**Aquinas High School Addition
3420 Main Road
David City, NE**

ADDENDUM NO. 1-1

ADDENDUM

Addendum No.: 1

AD001.M101-2

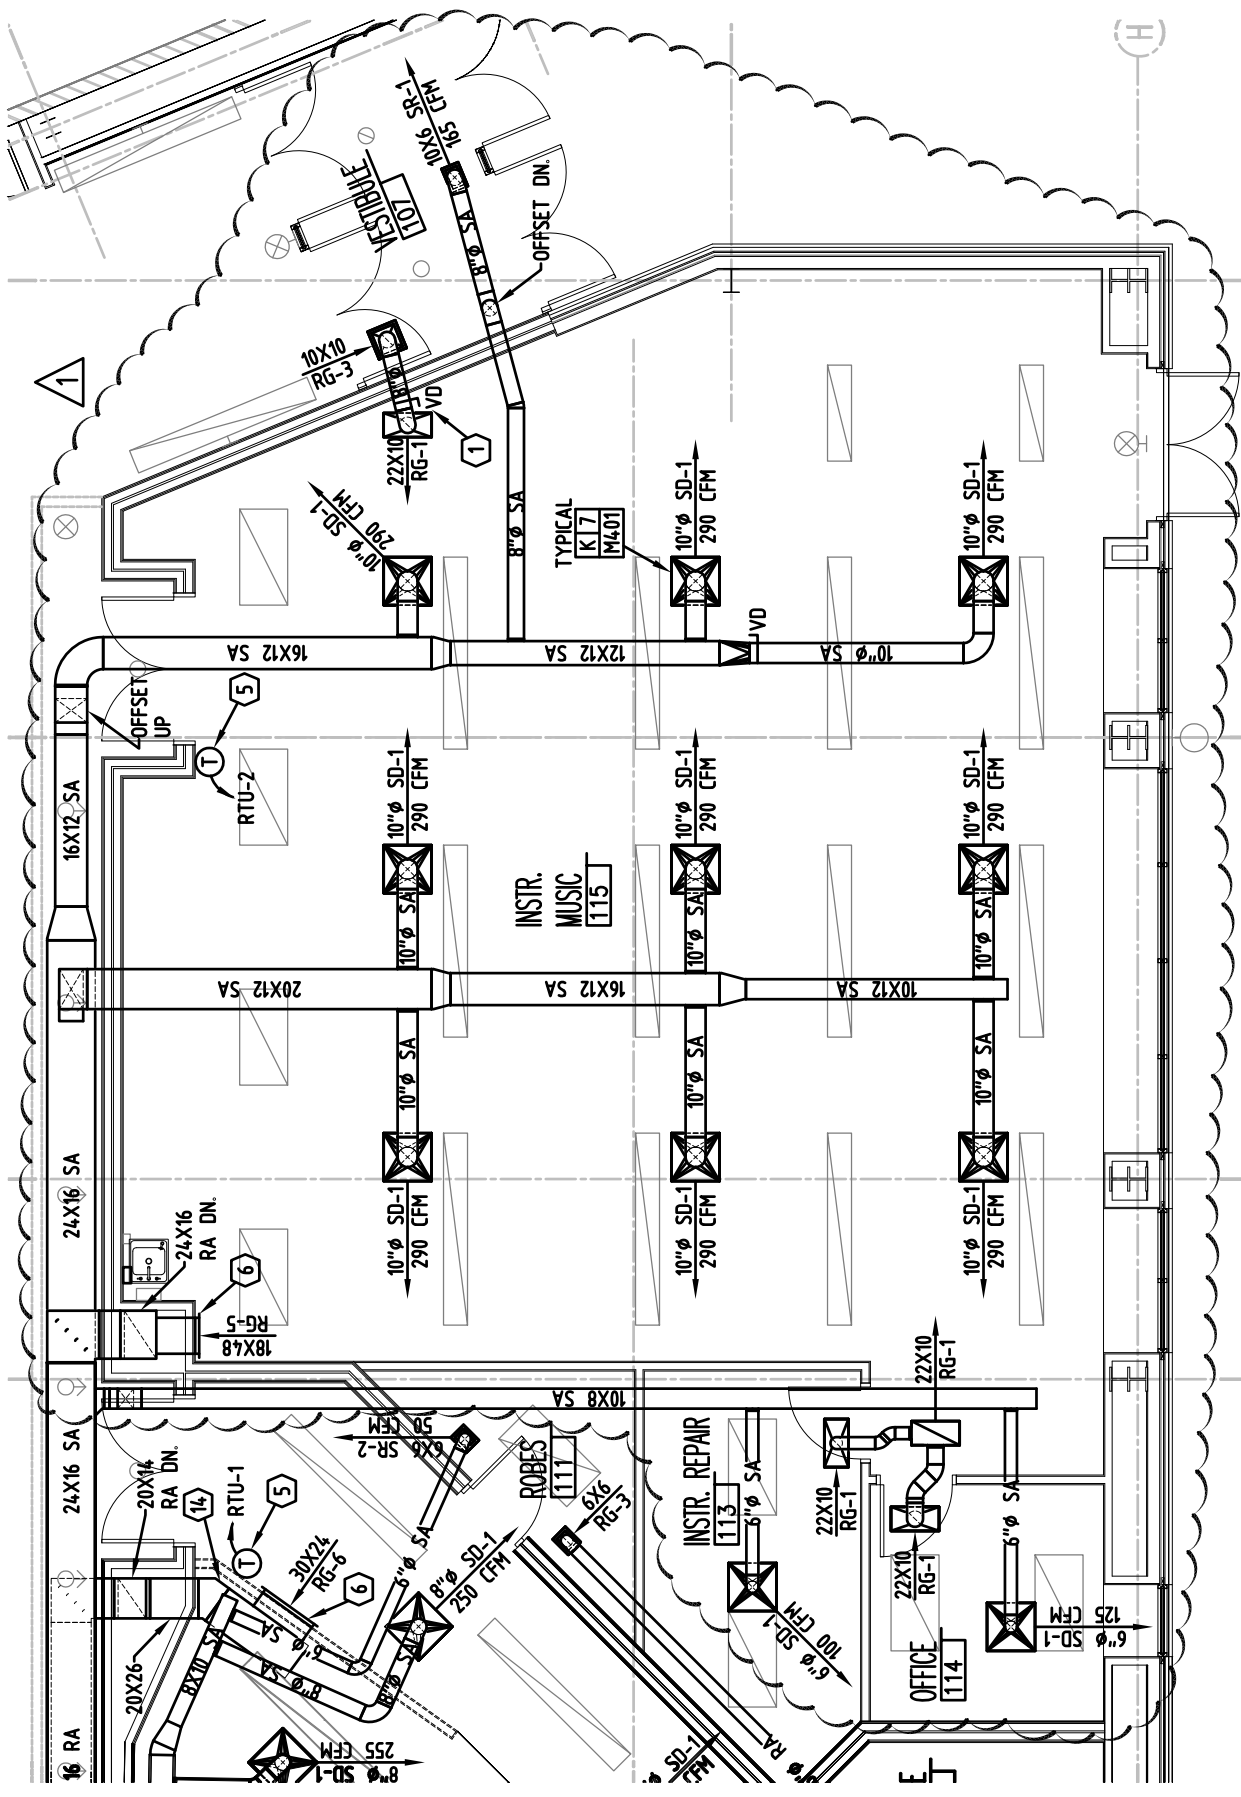
- 1) At Boys Restroom 124, extend 1/2" domestic cold water piping from Chase 123 to electric water coolers (EWC-1's) located to the west in Corridor 101. Refer to attached supplemental drawing AD001.M101-2 for details.

SHEET: **M201**
 AD001.M201-1

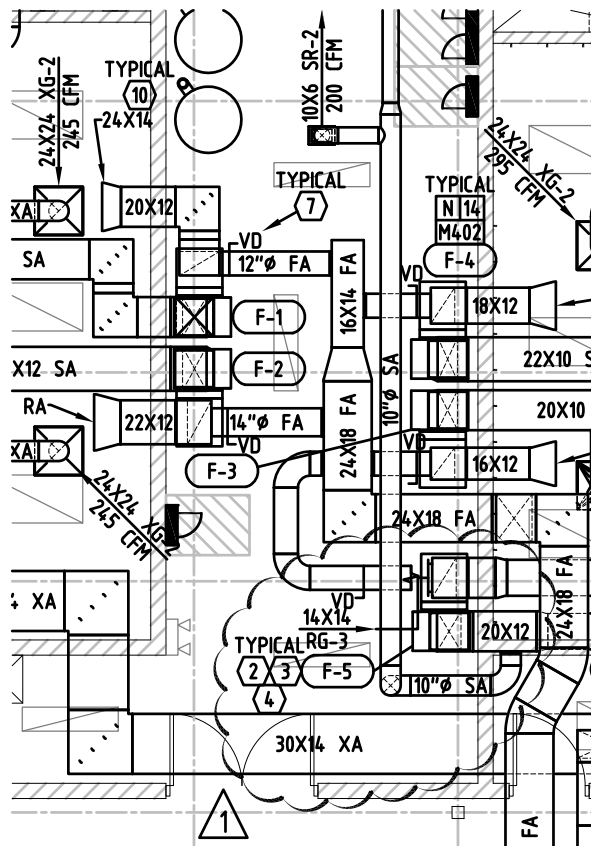
- 1) At Instr. Music 115, revise supply air ductwork layout to be installed between building structure as shown on attached supplemental drawing AD001.M201-1. Install ductwork as high as possible to allow for high ceilings in this room.

AD001.M301-1

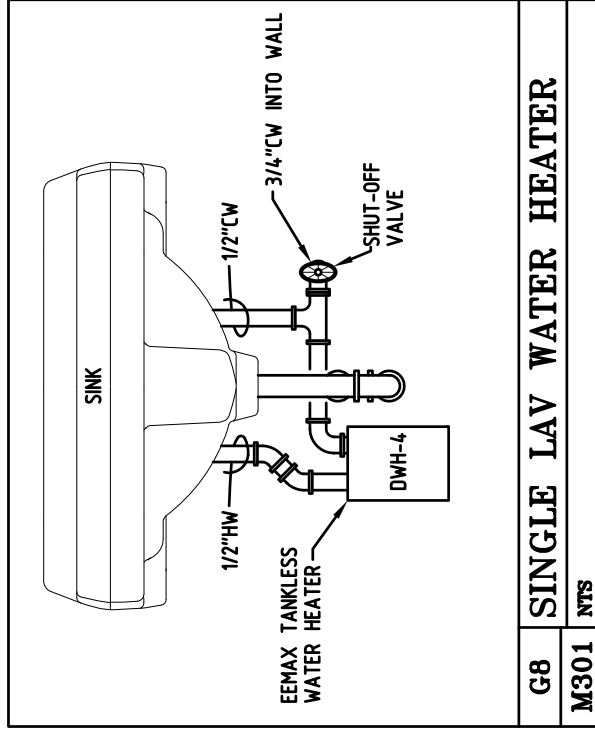
- 1) At Domestic Water Heater Schedule, domestic water heaters 1, 2 & 3 shall be A.O. Smith BTH-500A ASME Rated water heaters in lieu of BTH-500 water heaters. Refer to attached supplemental drawing AD001.M301-1 for details
- 2) At Domestic Water Heater Schedule, add domestic water heater 4 – 3.0kW electric instantaneous water heater to schedule. Refer to attached supplemental drawing AD001.M301-1 for details.

SHEET:
M301
 AD001.M301-2

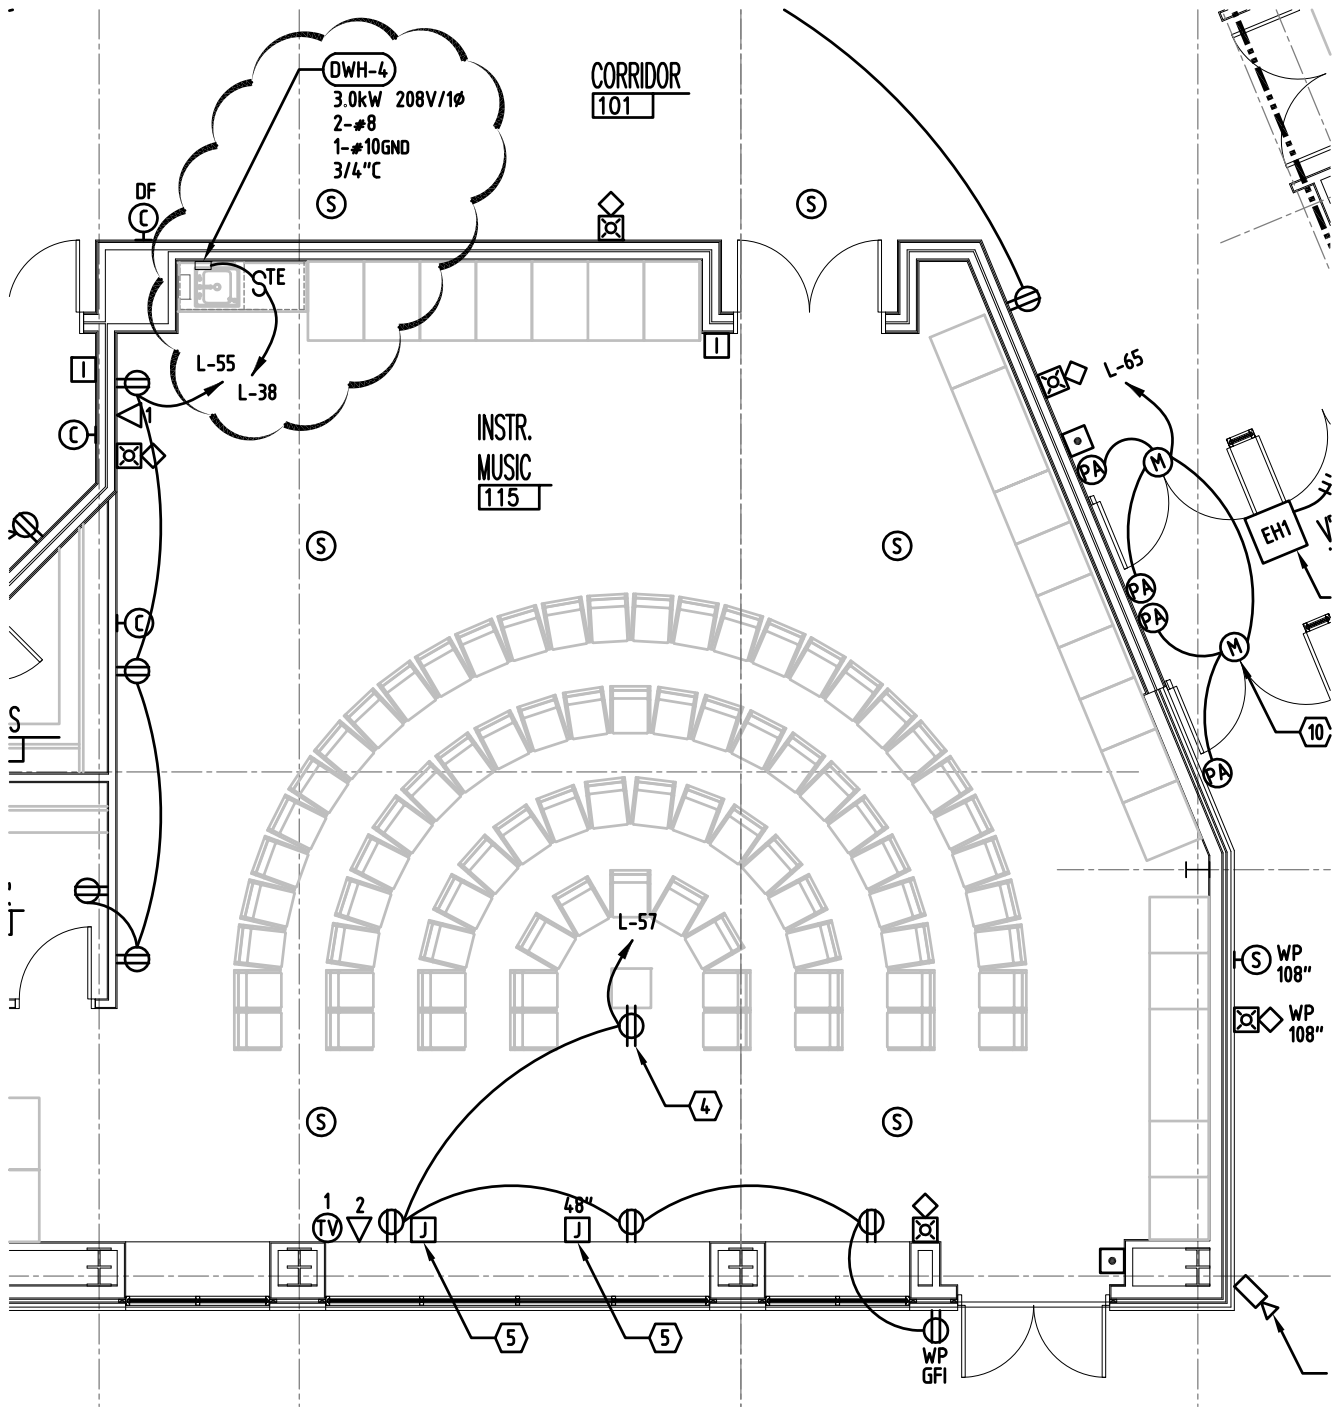
- 1) At Instr. Music 115, provide a new sink (S-1) in cabinetry in the northeast corner of the room. Extend 2" waste piping from sink to main waste line to the north. Extend 3/4" domestic cold water piping from Boys Restroom 124 to new sink location. Provide a new 3.0kW electric instantaneous water heater located under sink (S-1). Refer to attached supplemental drawings AD001.M101-1, AD001.M101-2, AD001.M301-1 & AD001.M301-2 for details.
